TENDER NO. MANPBT0028 EPC project for development of BESS at Ramagundam

Addendum: 01 Date: 11.11.2025

Amendments - EPC PACKAGE FOR DEVELOPMENT OF BESS AT NTPC THERMAL POWER STATIONS (Lot-1)

<p align="center">NTPC Limited (A GOVERNMENT OF INDIA ENTERPRISE) ENGINEERING DIVISION</p>	
PROJECT		<p align="center">BATTERY ENERGY STORAGE SYSTEM (BESS) AUX POWER SUPPLY ARRANGEMENT</p>	
TITLE		<p align="center">SINGLE LINE DIAGRAM</p>	
SIZE A1	SCALE NTS	DRG. NO. 9999-000-POE-A-001	REV. NO. C

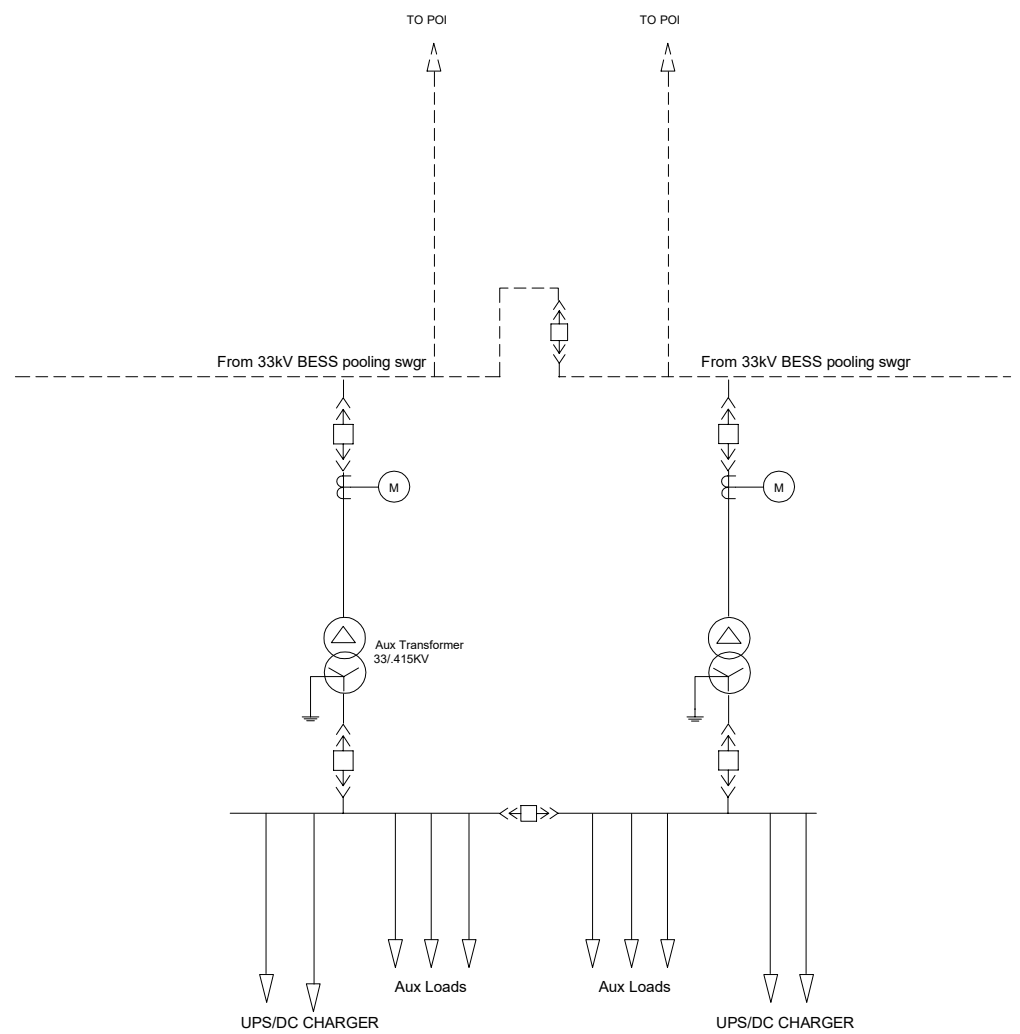
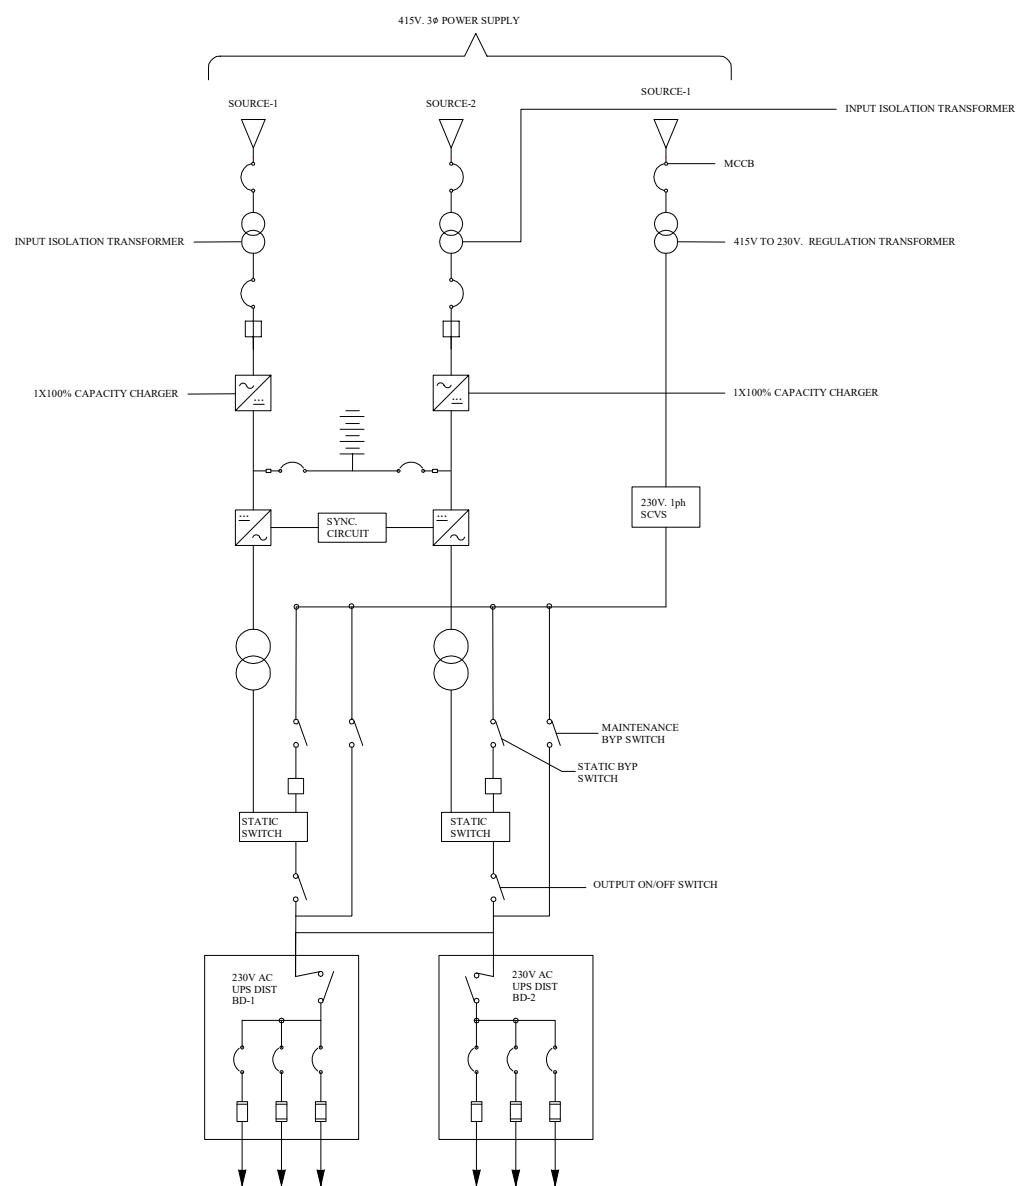
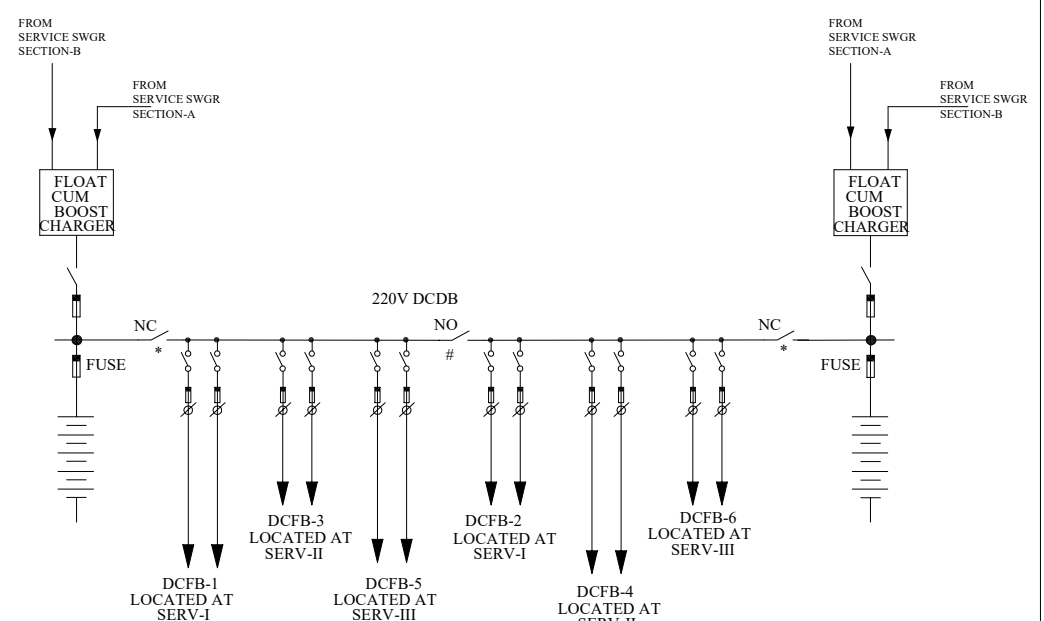
EXISTING SPECIFICATION			TO BE READ AS		
Tender SLD Rev B			Tender SLD Rev C as Annexure 1		
b) Tie Transformer and it’s components (OLTC, Bushing, etc) shall be designed for 110% over load condition continuously without exceeding temperature rise limits as specified above, also Tie Transformer shall be designed for overloading as per IEC 60076 without any adverse impact on the transformer. Transformer Name plate shall mention Transformer MVA rating corresponding to 110% rating of Transformer.			b) Tie Transformer and it’s components shall be designed for cyclic loading, continuous loading and over load condition as per IEC 60076 without any adverse impact on the transformer.		
Project	Bay details for Point of interconnection		Project	Bay details for Point of interconnection	
Kudgi 240x 2 Hrs 2 Bays	Existing 220 kV bay no 8 & 9 Main Bus bar available. Only bay equipments are to be provided.		Kudgi 240x 2 Hrs 3 Bays	400 kV bay no 30, 31 & 32 Main Bus bar available. Bay equipment to be provided.
